Re: Case No. 2023-00040

**TO:** Case File No. 2023-00040  
**FROM:** Moriah Tussey  
**DATE:** August 18, 2023  
**RE:** Informal Conference of August 17, 2023

The purpose of the IC was to discuss the proposed project and alternatives presented in the application in Case No. 2023-00040.

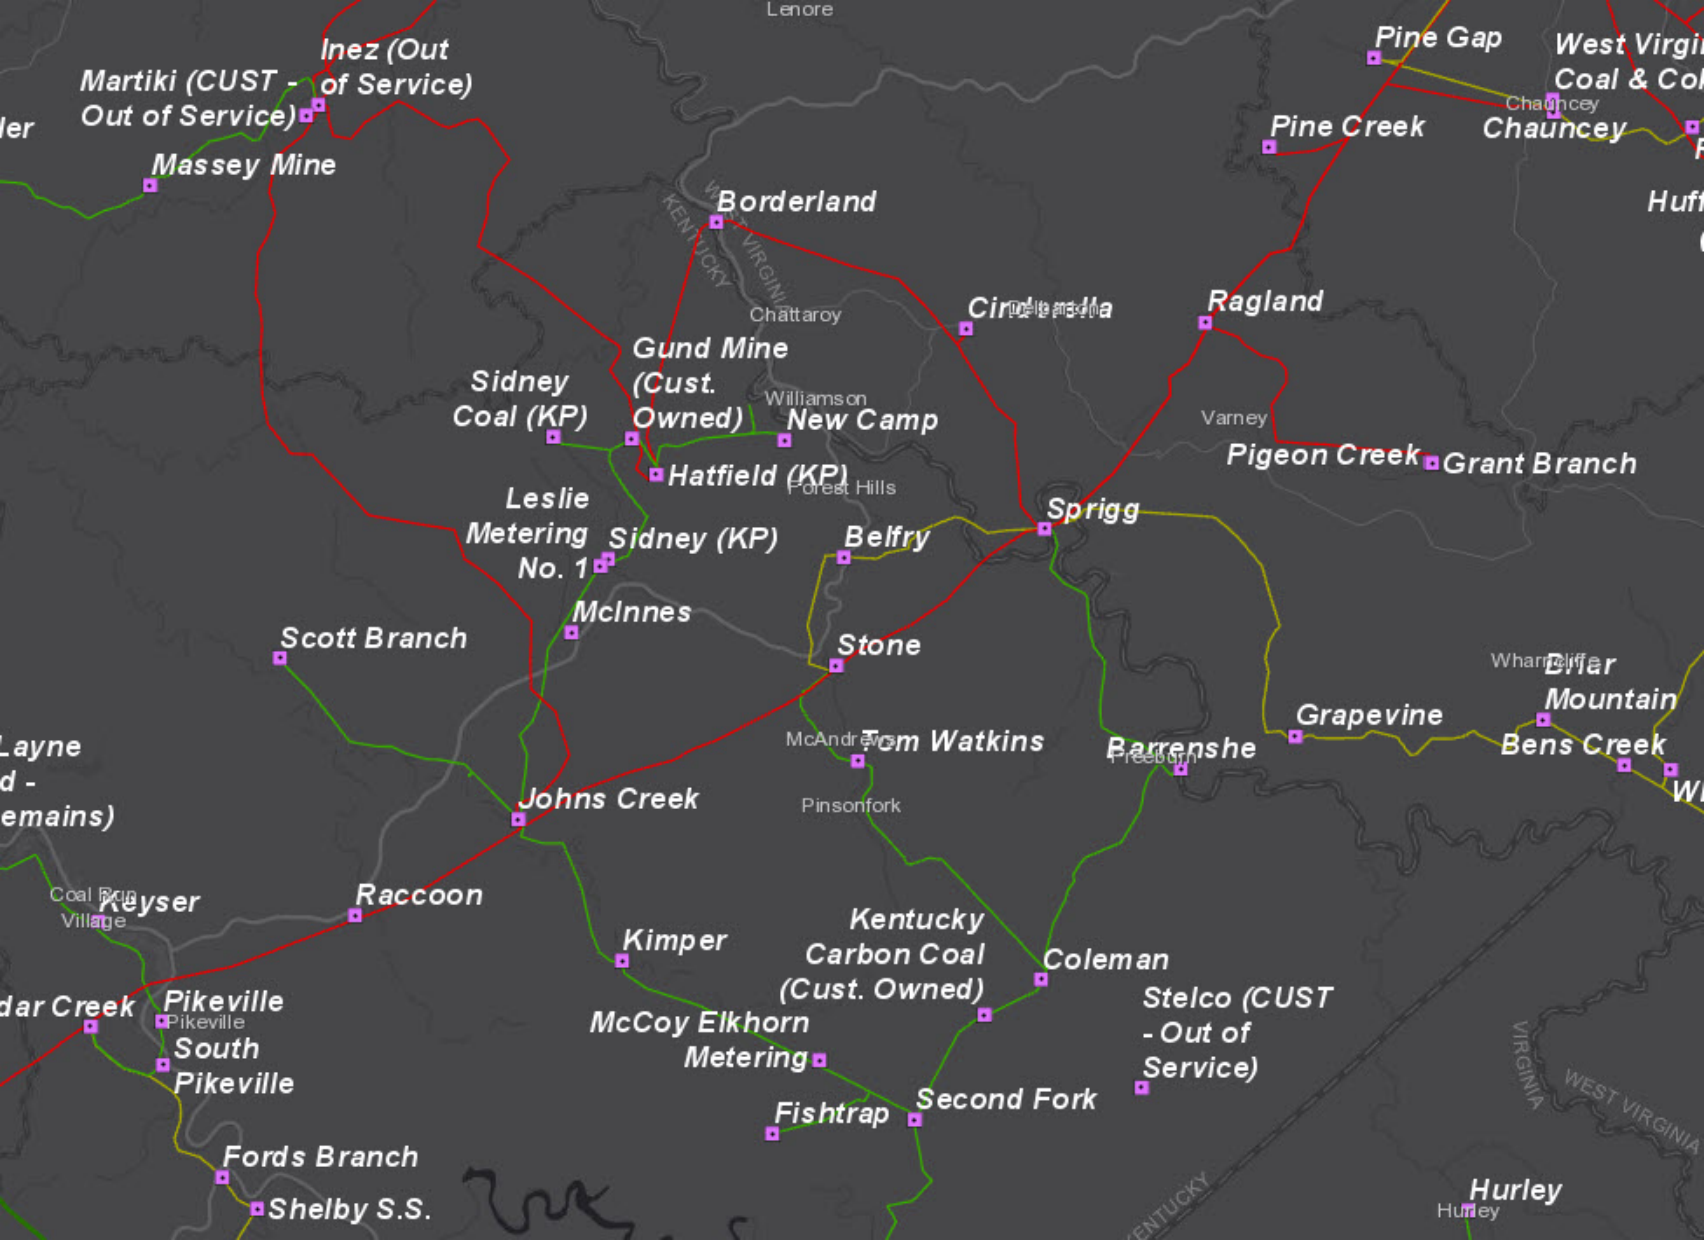
- Discuss alternatives presented in the CPCN
- Alternative #1: line through Johns Creek-Belfry-Stone
  - Single cap bank at Johns Creek station to address the 2020 PJM requirement
  - To fix baseline violations and an expansion on the original proposal
  - Rebuild yellow line between Stone and Sprigg
  - Rebuild 46 kV to a 69 kV
- Alternative #2: keep adding capacitor banks and various places on the lines in the area and the difficulties that solution would present
- Kentucky Power presented a map that was part of PJM approval process that will be attached to this memo filing.
- Kentucky Power indicated that it would file supplemental testimony to support its application.
